RIVERBEND CROSSING FILING NO. 1 & 2

GRADING & EROSION CONTROL PLANS

PCD File No. SF-18-044

RIVERBEND CROSSING
FILING NOS 1 & 2
EROSION CONTROL PLANS
& DETAILS

DESIGNED BY: MGP	DRAWN BY: MGP
SCALE: N/A	DATE: 02/10/20
JOB NUMBER: 17-114	SHEET: 1 OF 4

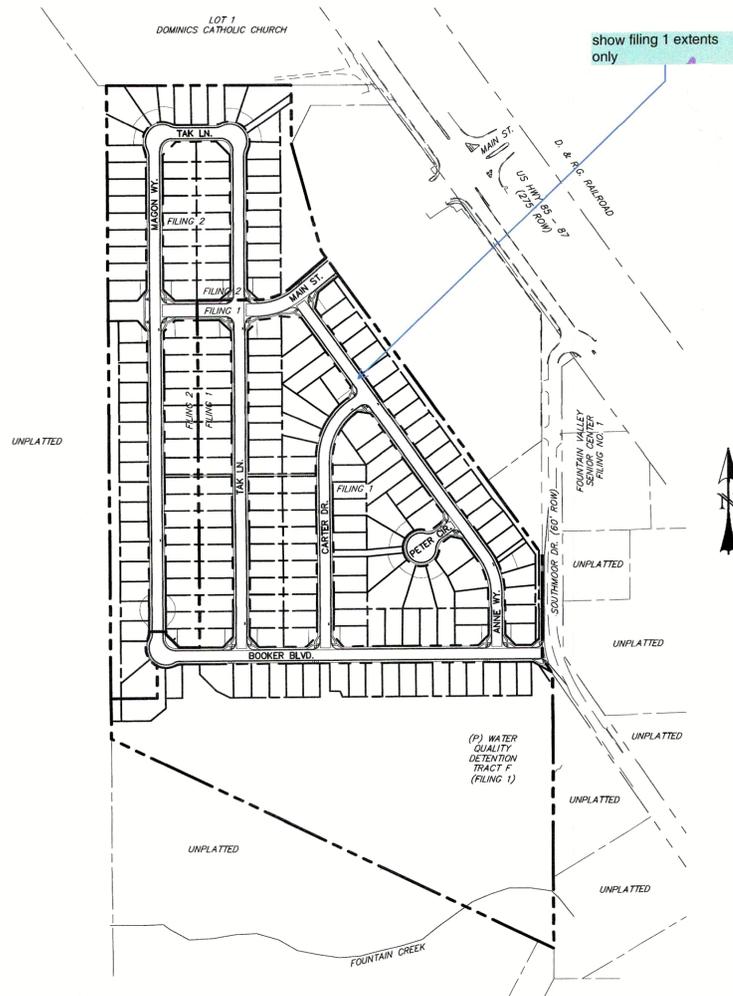
Provide construction plan & details for the channel bank stabilization in either the GEC or the Construction Documents.

Update notes using GEC Checklist page 2 and 3

Update notes using section 3 on GEC Checklist

DESIGNED BY:	DLM	DRAWN BY:	MGP
SCALE:	1" = 60'	DATE:	02/10/20
JOB NUMBER:	17-114	SHEET:	2 OF 4

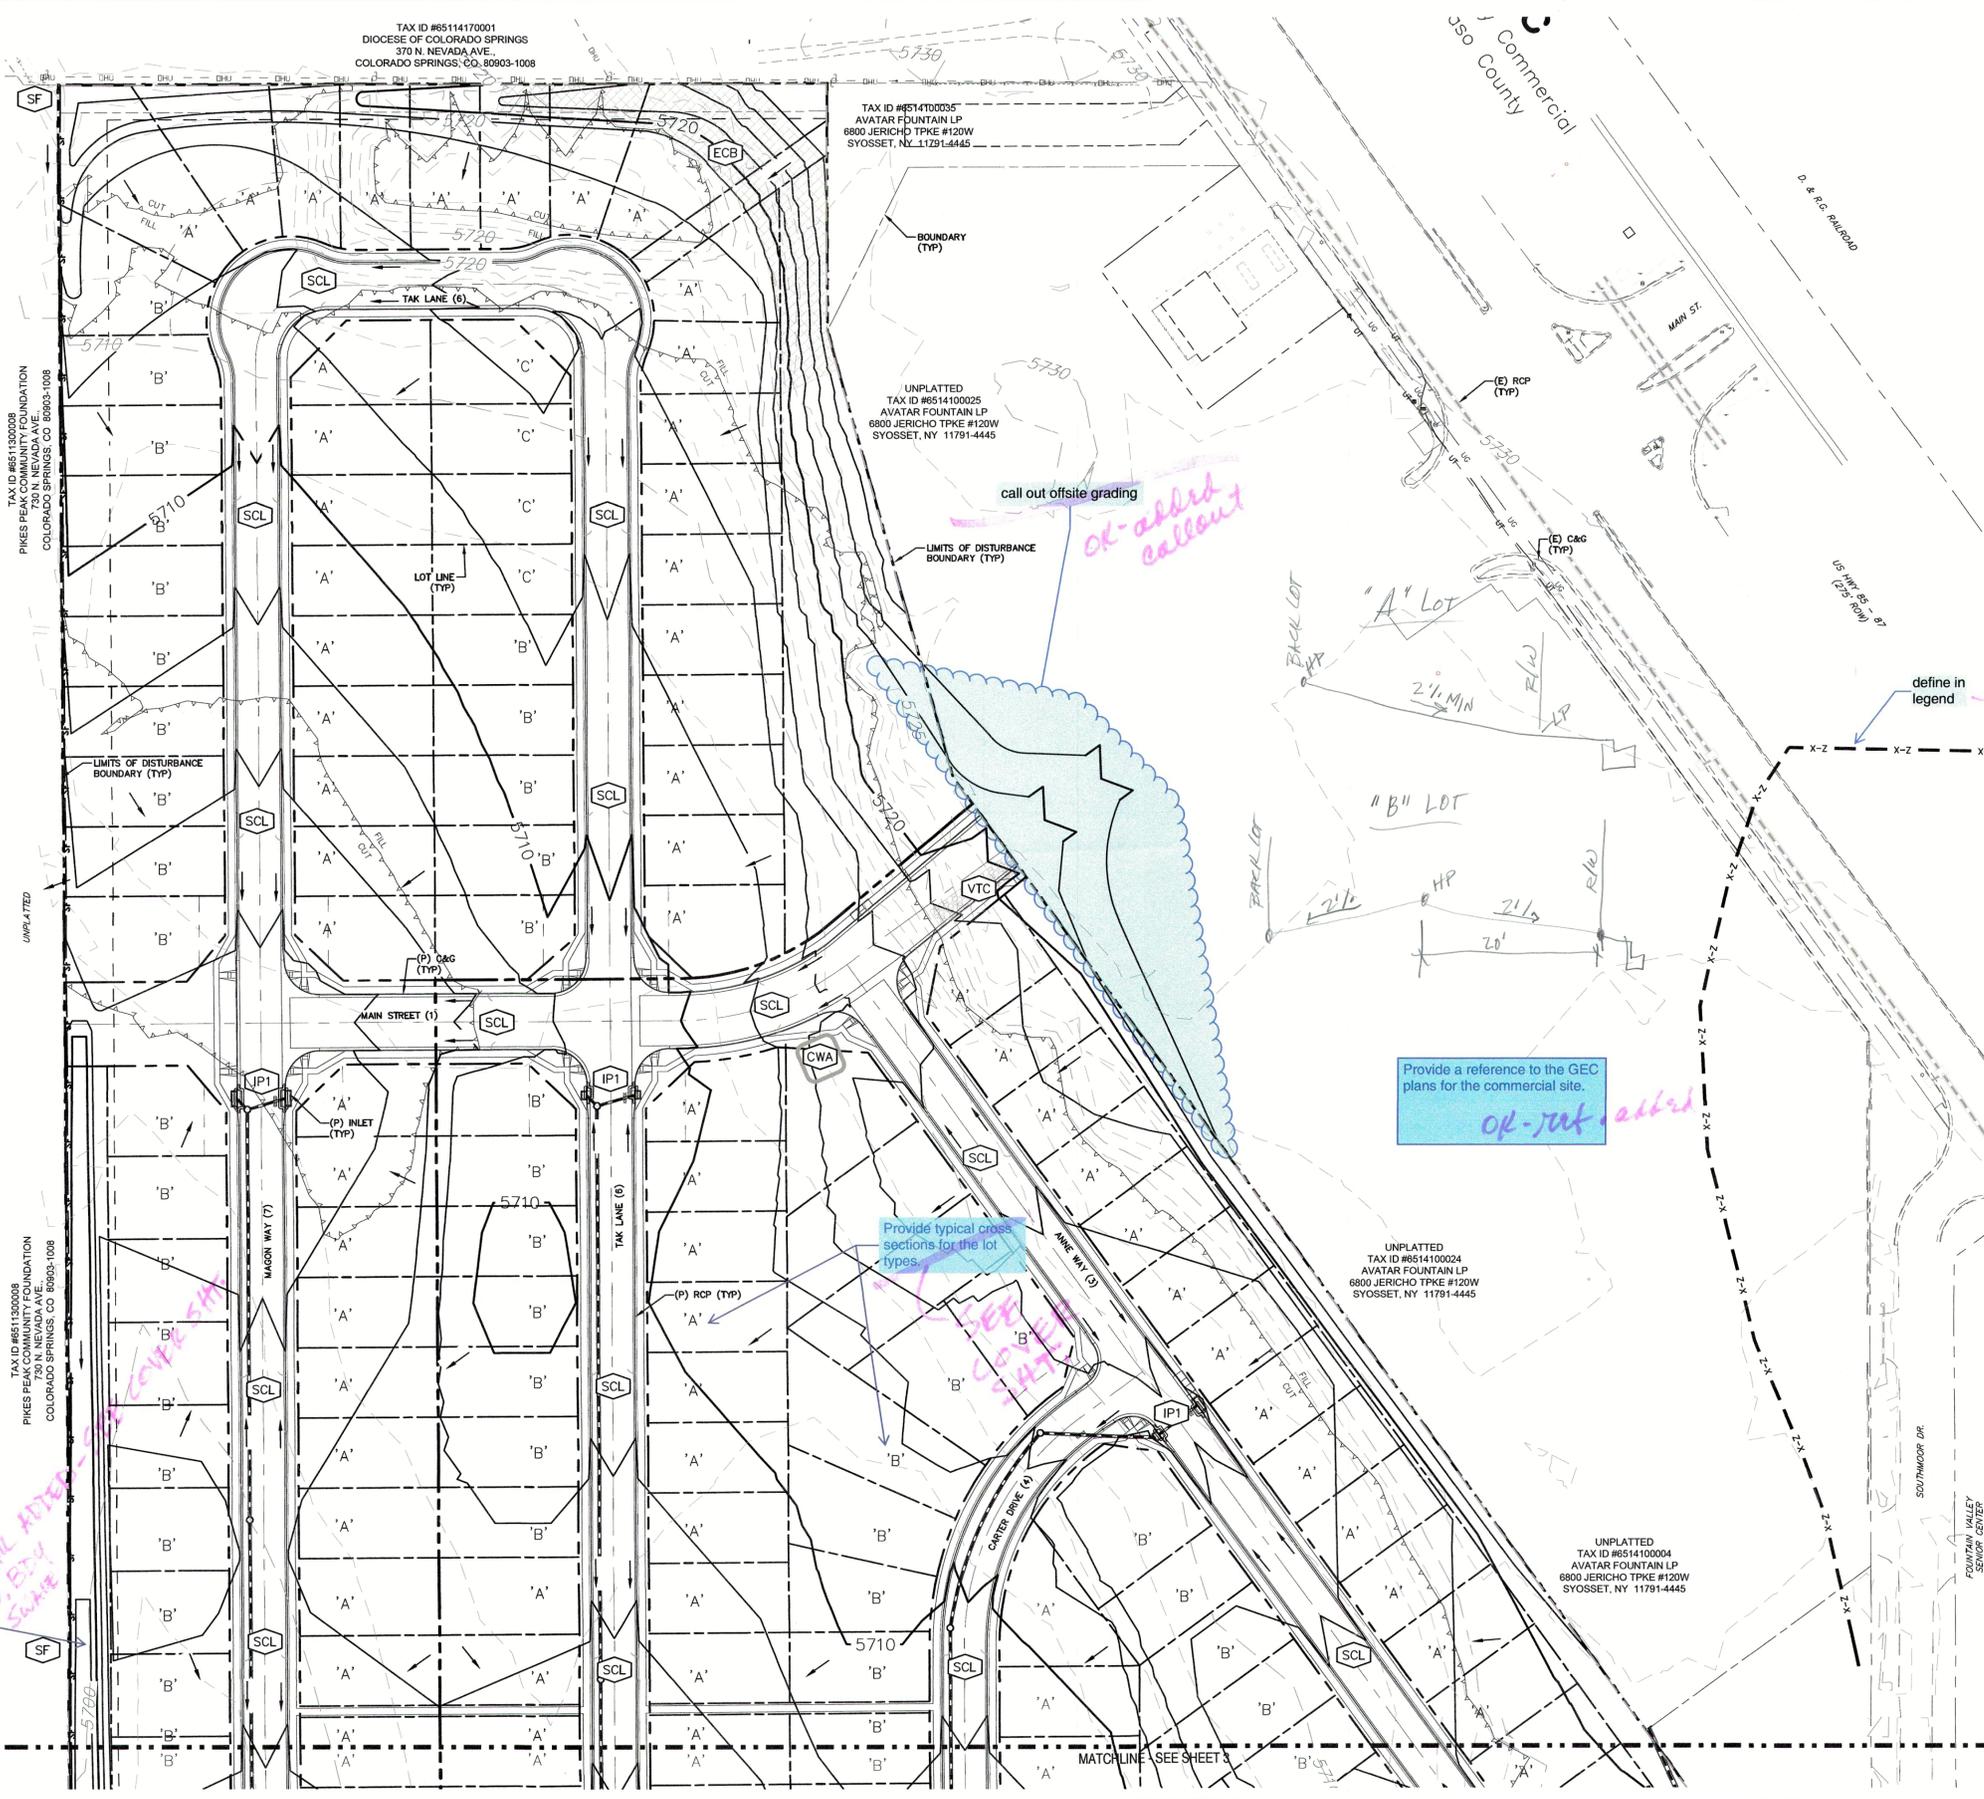
Define as construction or property boundary

DESIGNED BY:	DLM	DRAWN BY:	MGP
SCALE:	1" = 60'	DATE:	02/10/20
JOB NUMBER:	17-114	SHEET:	3 OF 4

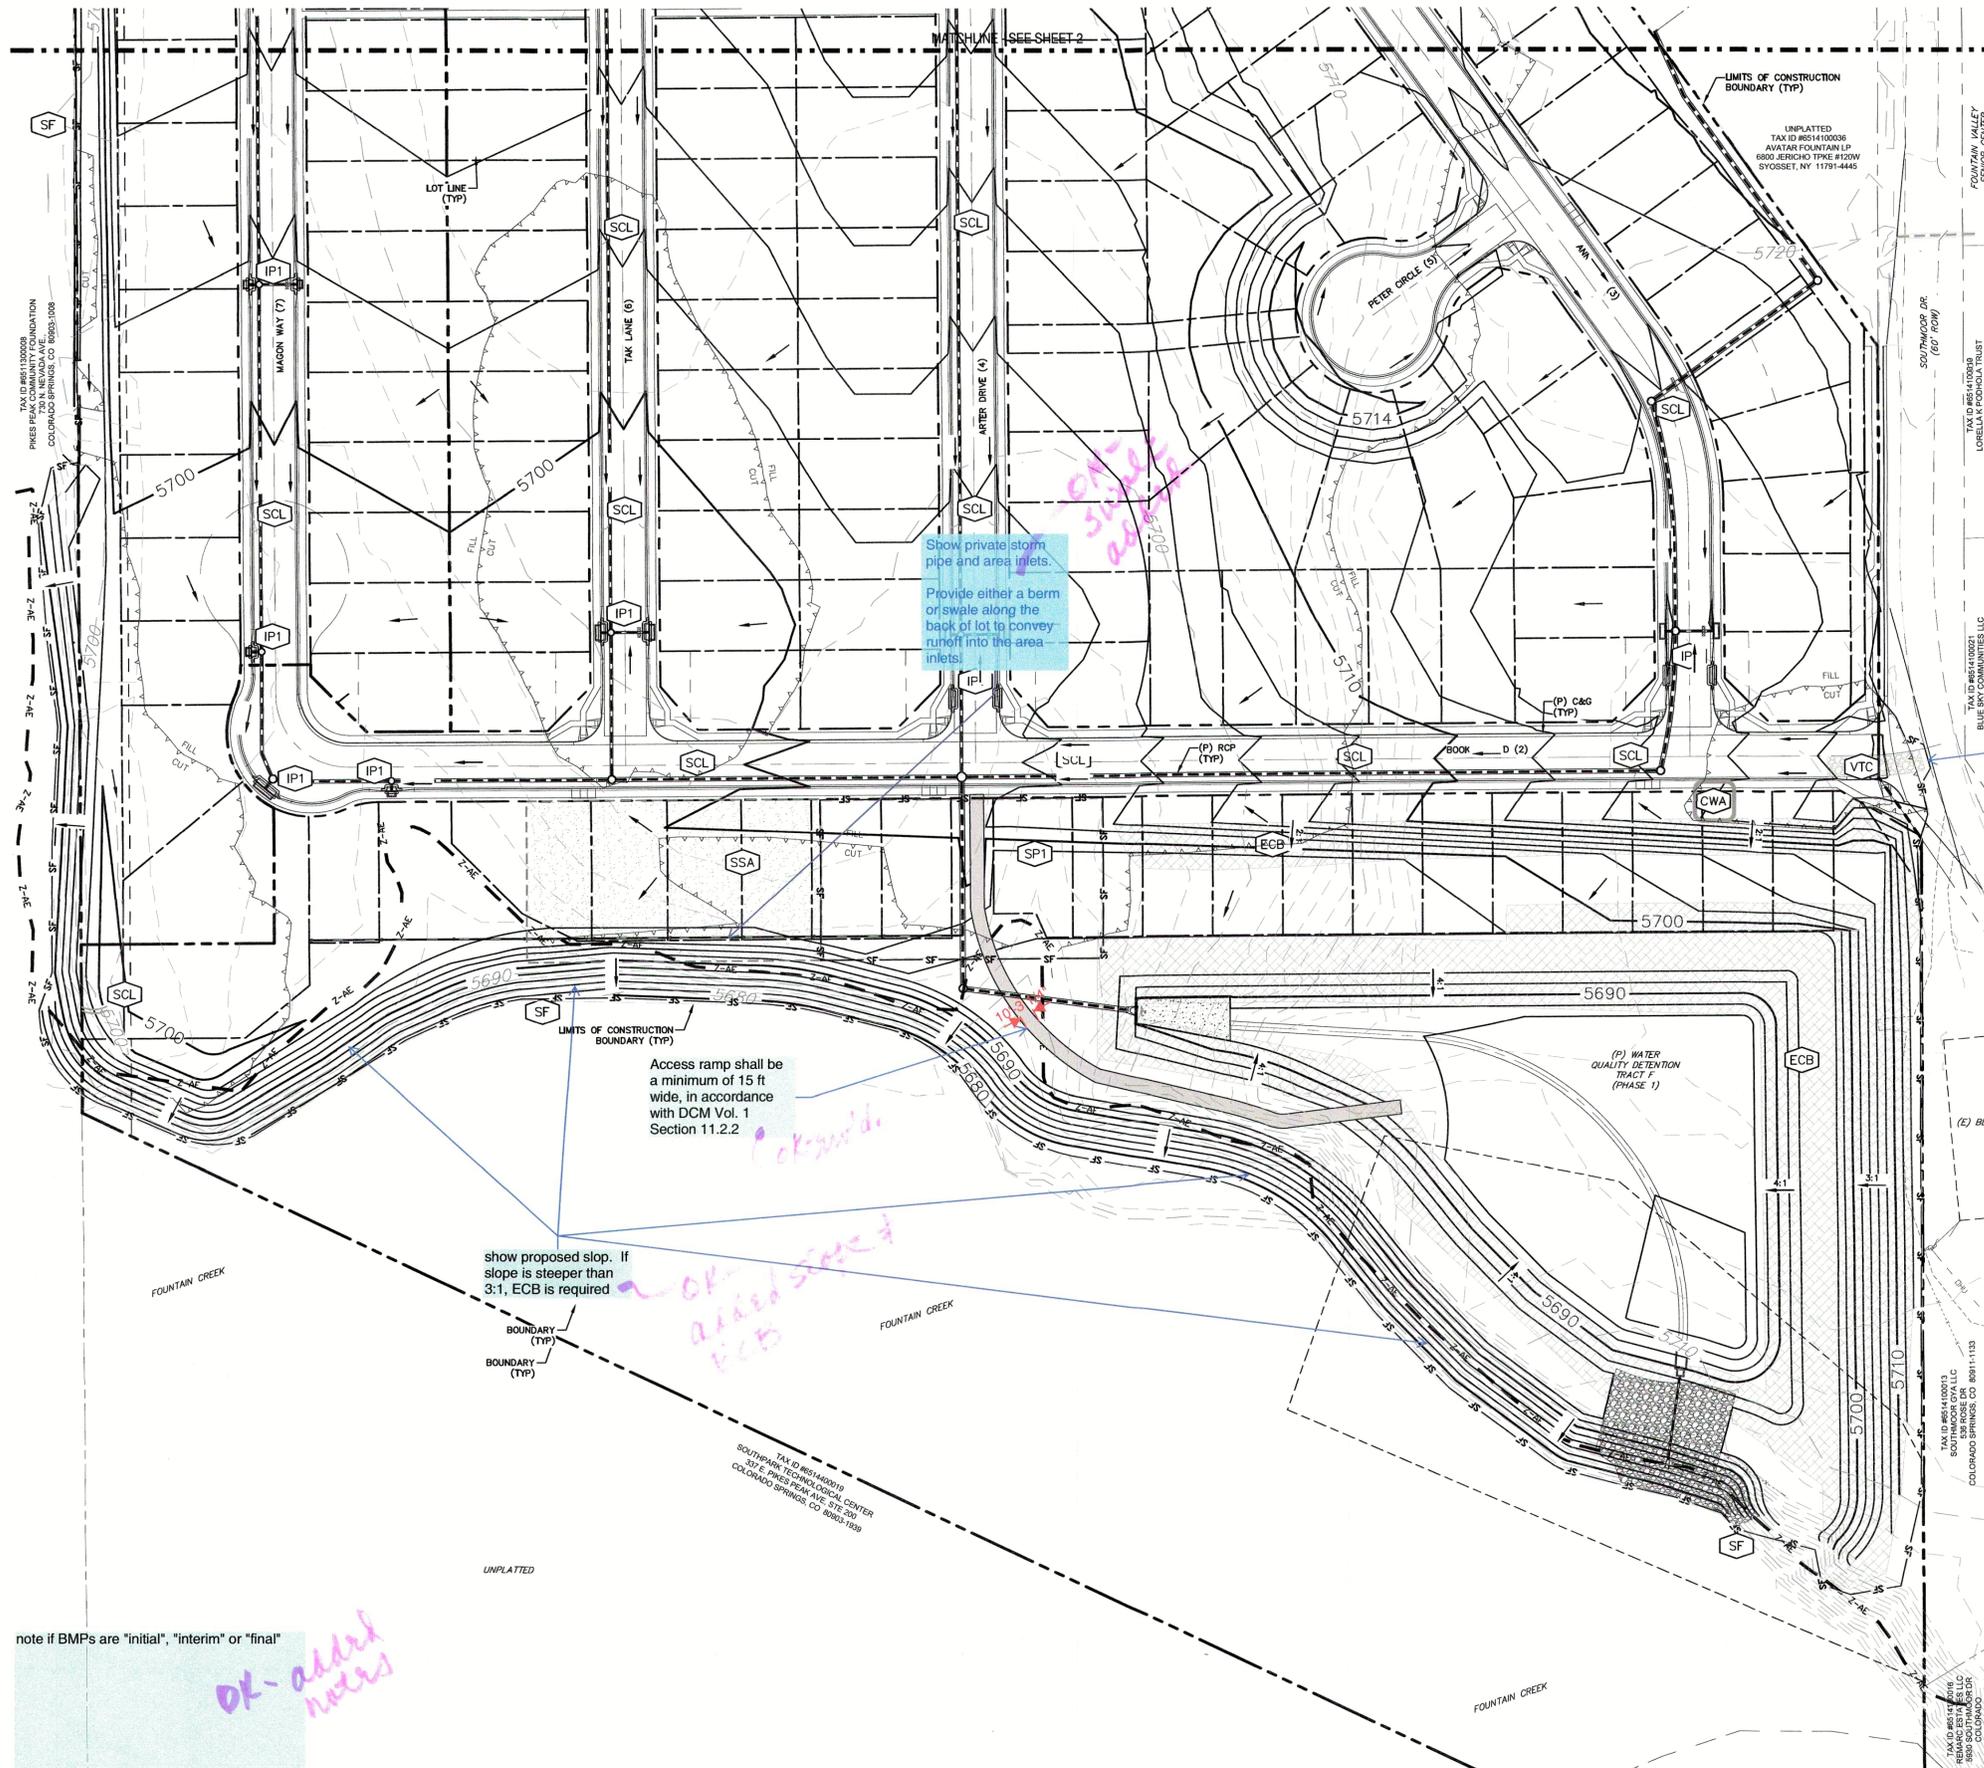
remove silt fence to allow for vehicle ingress/egress

Access ramp shall be a minimum of 15 ft wide, in accordance with DCM Vol. 1 Section 11.2.2

show proposed slope. If slope is steeper than 3:1, ECB is required

note if BMPs are "initial", "interim" or "final"

show private storm pipe and area inlets

provide either a berm or swale along the back of lot to convey runoff into the area inlets

OK - added notes
